SANITARY AND STORM WATER SEWER EXTENSION

IN
 BRADLEY FAIR 3RD ADDITION
 CITY OF WICHITA PRIVATE PROJECT NO. 812PPS (607861)

As-Constructed Drawings
Sanitary Sewer Improvements
Bradley Fair 3rd Addition
Proj. No. 812PPS - Index Code 607861
Wichita, Kansas

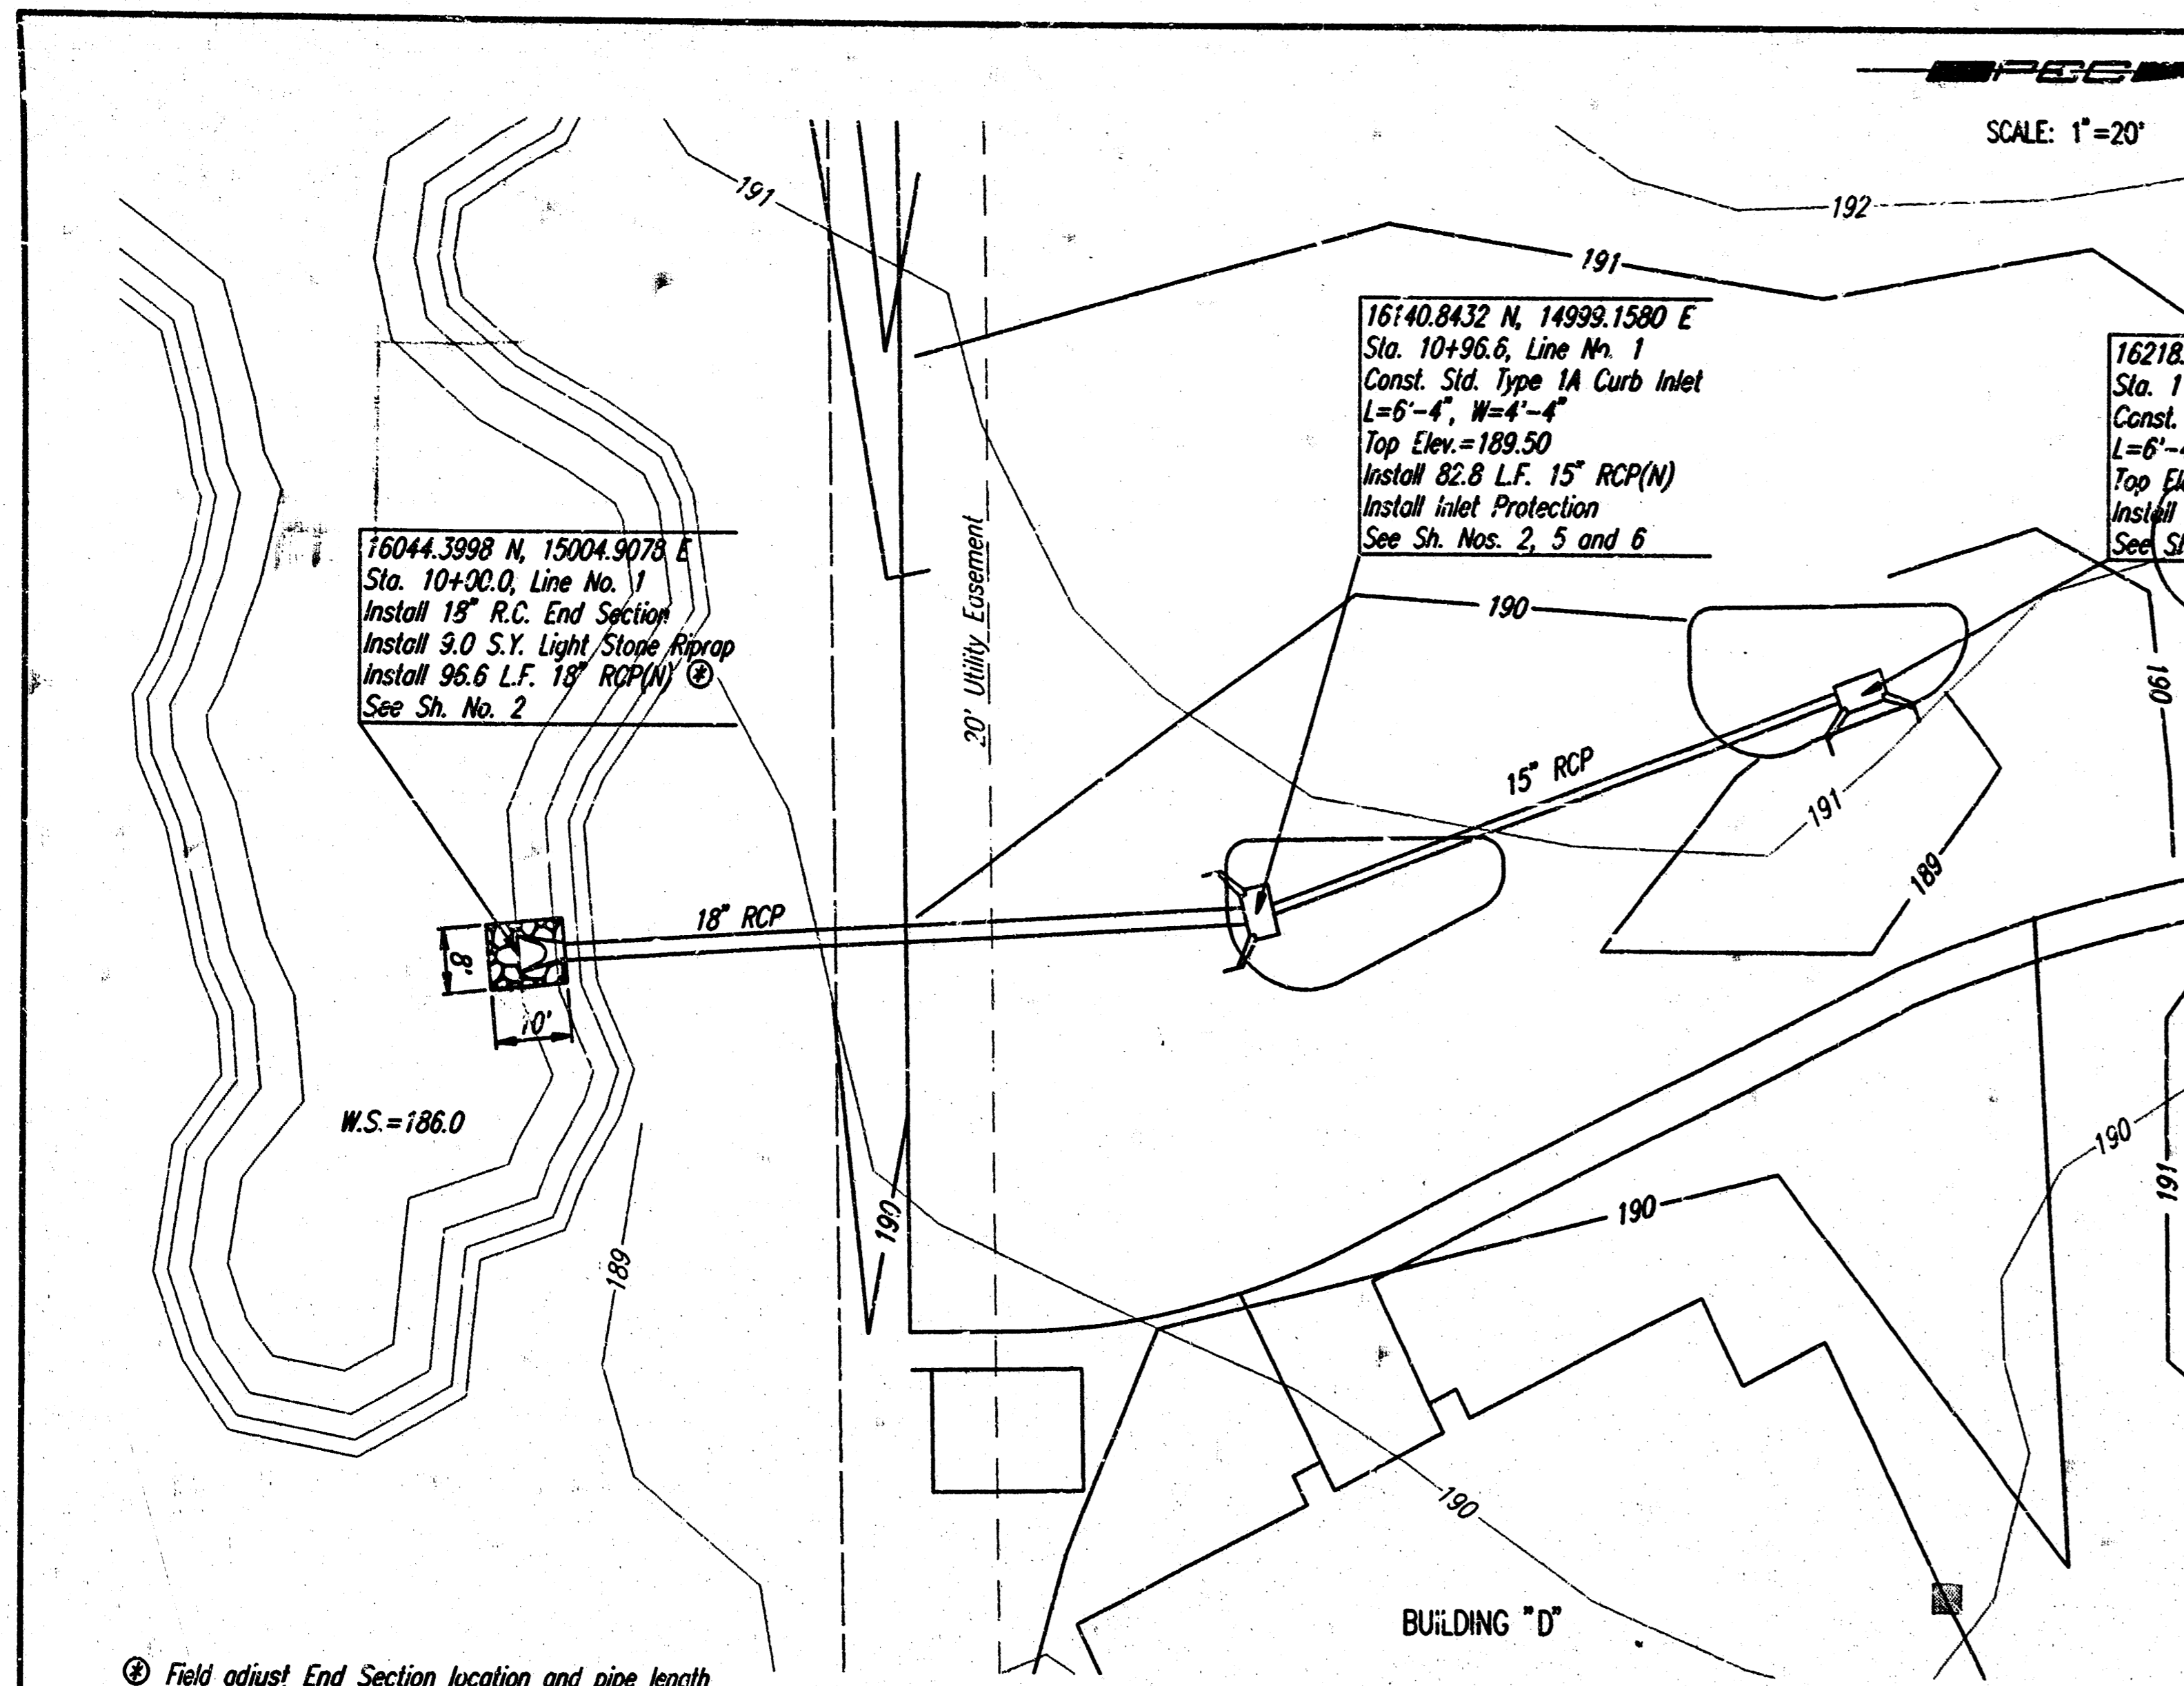
Field adjust End Section location and pipe length to match Pond Bank.
